MANDATORY SERVICE BULLETIN

MSB 42-149

MSB 42NG-095

Actions to prevent Passenger Door Separation: Installation of Placards, AFM Procedure update and Inspection/Data Gathering.

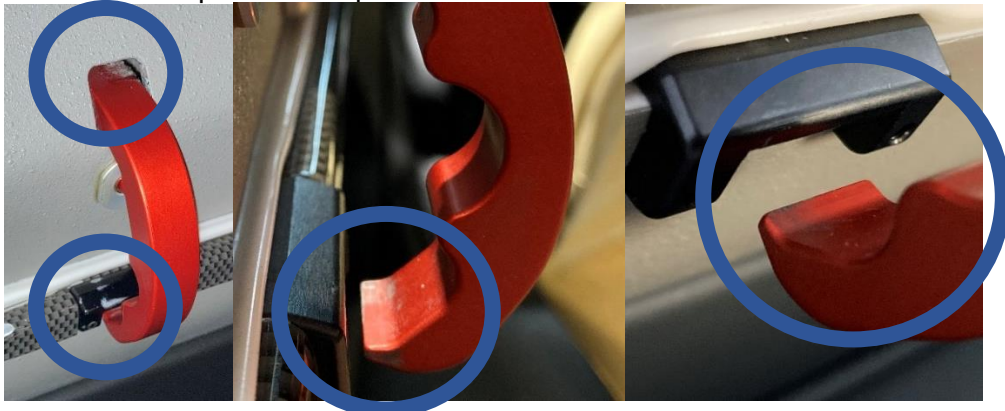
- Pay particular attention to the hook end of the Safety Hook.
 - The hook end must not be bent.
 - Not acceptable:

Replace Safety Hook, if

- any of the Safety Hook dimensions measured in this step are not within the given tolerances, or
- corrosion is found, or
- deformation, grooves, ridges or steps.

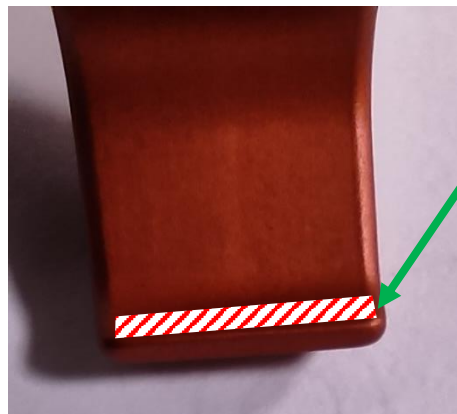
- Examine the tip of the Safety Hook for wear:
 - Wear of edges of Safety Hook:
 - The width of the tip of the Safety Hook must be greater than 10.5 mm.

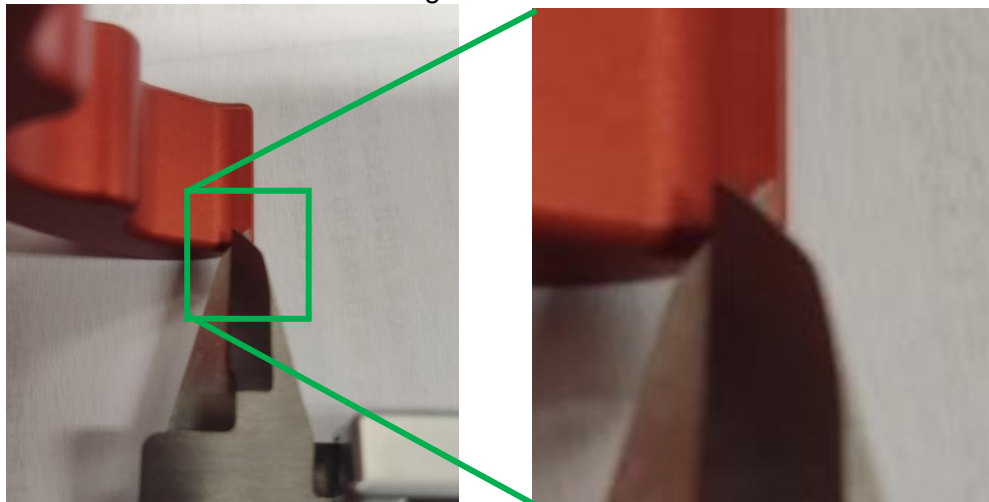
- The engaging surface of the Safety Hook is the flat surface at the tip of the Safety Hook.
 - It must be free from steps and ridges.
 - Scratches or uniform wear of surface protection are permitted.

- Measure the width of the engaging surface.
 - The width must be greater than 1.5 mm.

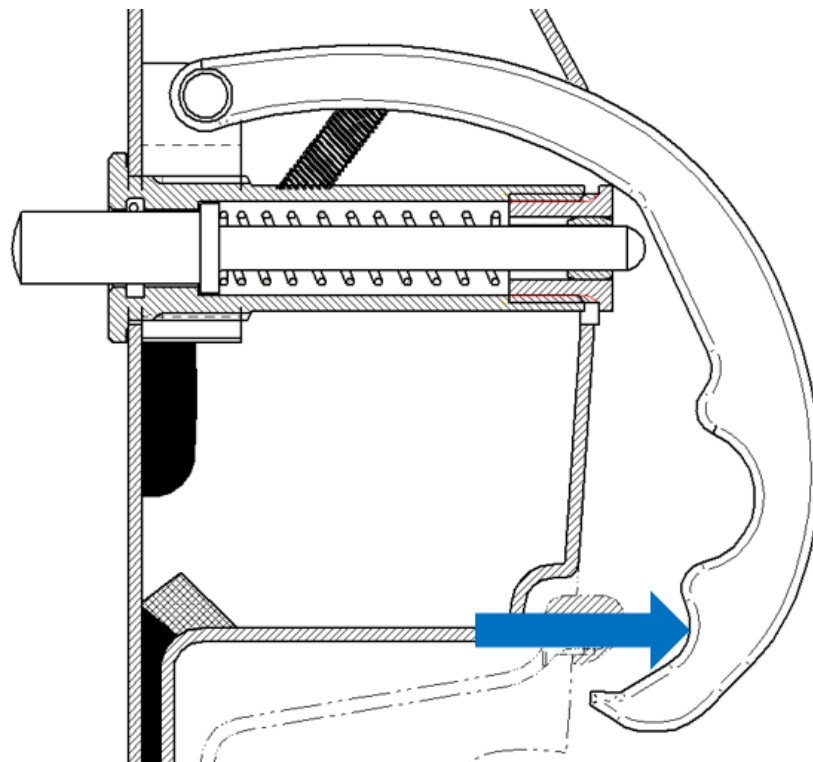
- Measure the maximum thickness of the Safety Hook at the location of the engaging surface, perpendicular to the engaging surface.
 - The thickness must be greater than 2.5 mm.
 - The maximum variation of measured thickness over the width of the Safety Hook must be less than 0.2 mm.

- Measure the minimum thickness of the Safety Hook at the location of the engaging surface, perpendicular to the engaging surface.
 - The minimum thickness must be greater than 1.5 mm.
 - The maximum variation of this value over the whole width must be less than 0.2 mm.

- The edge of the engaging section of the Safety Hook that is facing towards the Retaining Bracket must be free from ridges.

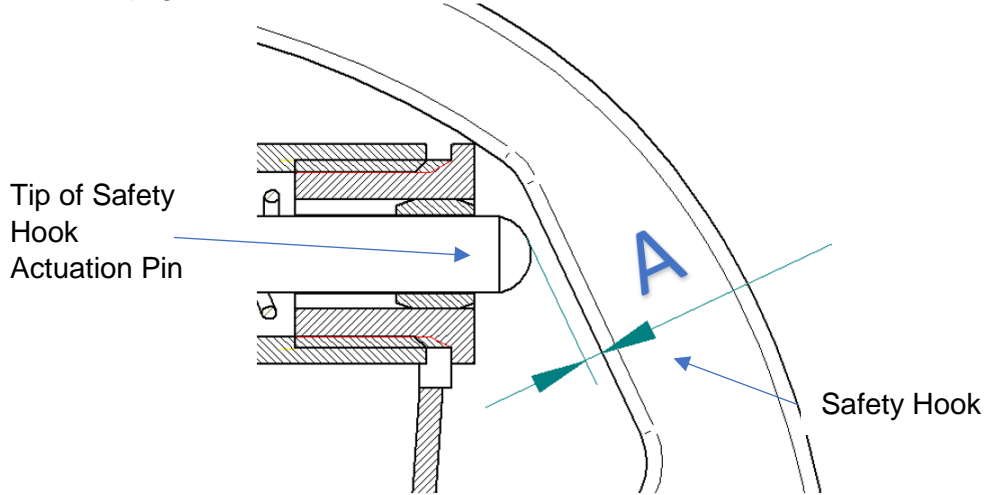
11 Examine if the Safety Hook properly engages in the Retaining Bracket:

The Safety Hook Actuation Pin must not be pressed during this step.

- Close and latch the Passenger Door.
- Unlatch the Passenger Door from the outside and pull on the outer Passenger Door Handle.
 - The Safety Hook must engage in the Retaining Bracket and prevent the Passenger Door from further opening.
- Pull on the outer Passenger Door Handle with 15 ± 1 kg / 150 ± 10 N.
 - The Safety Hook must not disengage but must remain properly engaged in the Retaining Bracket
- Record the check results on the execution report in Appendix B.

If the Safety Hook disengages, identify the cause, record it on the execution report in Appendix B **and** contact Diamond Aircraft Industries GmbH.

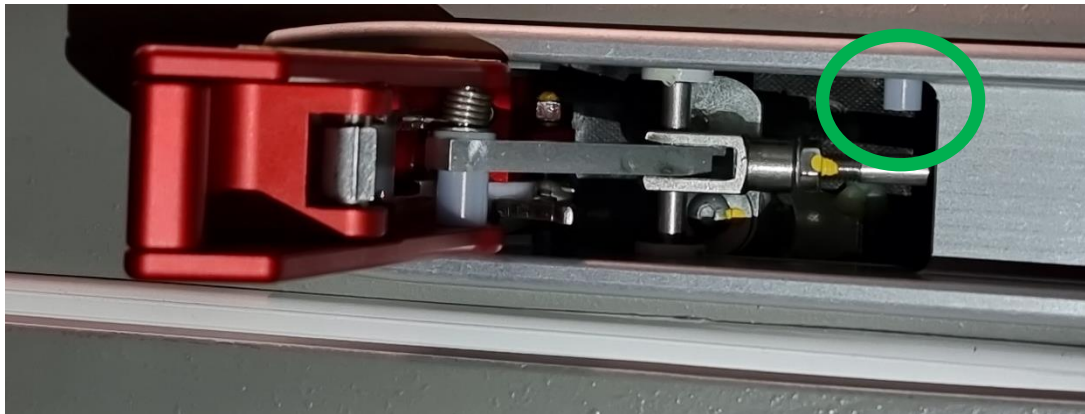
19 If MÄM 42-097 is installed (refer to step 15), examine the adjustment of the gas spring in the Passenger Door latching mechanism.

The gas spring inside the door handle must push the door handle into the latched position firmly against the stop:

- Open the Passenger Door.
- Move the Passenger Door Handle to the latched position.
- Examine, if the door handle is pushed into the mechanical stop inside the door handle mechanism (marked in the pictures below).
- If the Passenger Door Handle is not pushed against the mechanical stop by the gas spring, adjust the gas spring (refer to AMM section 52-10) and repeat this step.
- Record whether the gas spring was adjusted properly on the execution report in Appendix B.

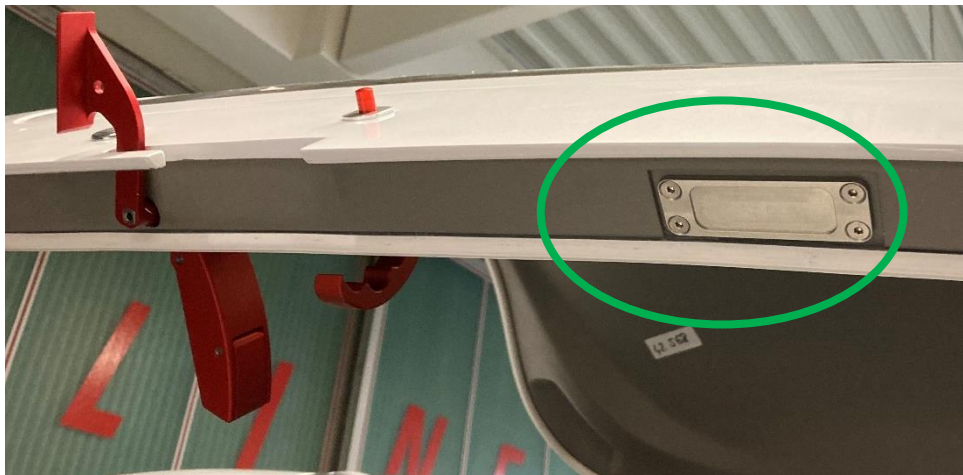
23 Measure the extension length of the latching bolts of the Passenger Door.

- Measure the extension length at the bottom of the front and rear latching bolts in mm. Refer to pictures below.
 - The front latching bolt extension length must be 40 ± 2 mm.

- If MÄM 42-687 is **not** installed, the rear latching bolt extension length must be 40 ± 2 mm.
 - If the extension length is out of tolerance, adjust the latching bolt if possible, or replace latching bolt if necessary.

- After adjustment or replacement repeat this step.
 - If MÄM 42-687 is installed, the rear latching bolt extension length must be 44 ± 1 mm.
 - If the extension length is out of tolerance, adjust the latching bolt if possible, or replace latching bolt if necessary.

- If the extension length is out of tolerance, adjust the latching bolt if possible, or replace latching bolt if necessary.
 - After adjustment or replacement repeat this step.

Placard on the Canopy handle

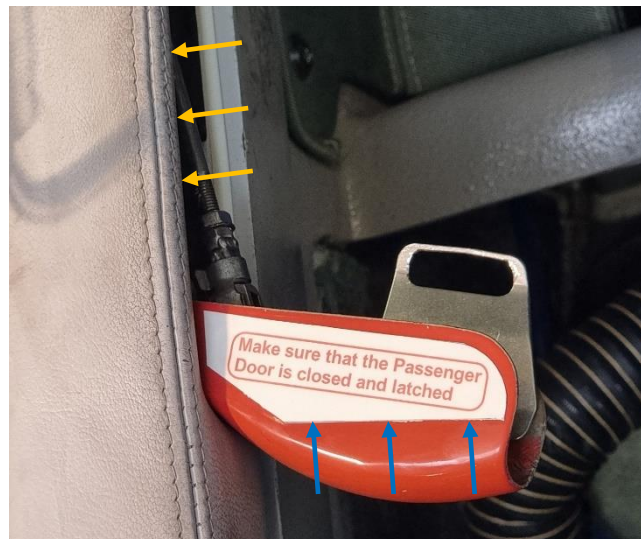
- 28 If MÄM 42-097 is installed (new latching mechanism, refer to step 15), install placard D60-1133-10-09 to the upper side of the inner canopy handle.

- Unlatch the canopy.
- Clean the canopy handle from dirt and grease.
- Align the placard with the straight edge and position it in spanwise direction so that it is completely visible from the pilot's perspective if the canopy handle is in the unlatched position.
- The placard must disappear when the canopy handle is in the latched position.

Placard on the Passenger Door

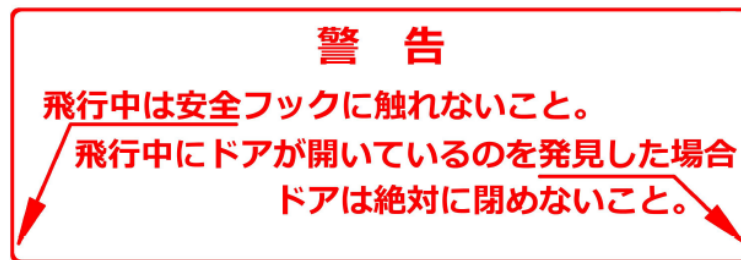
- 30 Install placard D60-1133-10-08 to the Passenger Door.
- For DA 42 NG airplanes that are registered in Hong Kong, use placard D60-1133-70-08.
 - For DA 42 NG airplanes with MÄM 42-600, that are registered in Japan, use placard D60-1133-61-08.
 - For DA 42 NG airplanes without MÄM 42-600 and DA 42 airplanes, that are registered in Japan, use the Japanese placard below:

- Clean the area where the placard will be attached from dirt and grease.
- Position the placard approximately 10 mm forward of the Safety Hook cut-out in the Passenger Door and approximately 10 mm above the Passenger Door Handle.
